SUBJ: Responses to Vendor's Questions

BID ITEM: Responses to Vendor Questions for Re-Bid Item #25-193A Highland Ave WTP Filter Rehabilitation-Phase 2 for Augusta, GA- Augusta Utilities Department

ADDENDUM NO. 2

1 TROUGH DETAIL
 MO6 MO6
 MO7 SCALE: NONE

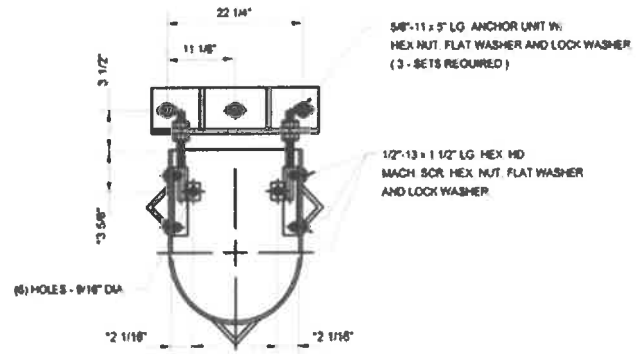
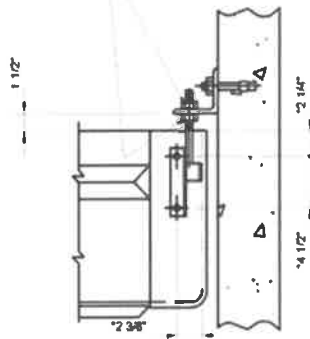
3. Question: The support details shown on Sheet M08 are unclear. Is there a section view provided that corresponds to or is opposite of Section B?
Response: Trough Detail 1 on page M-08 details the support of the troughs opposite of Section B. Please see image attached to page 2 of Addendum 2.
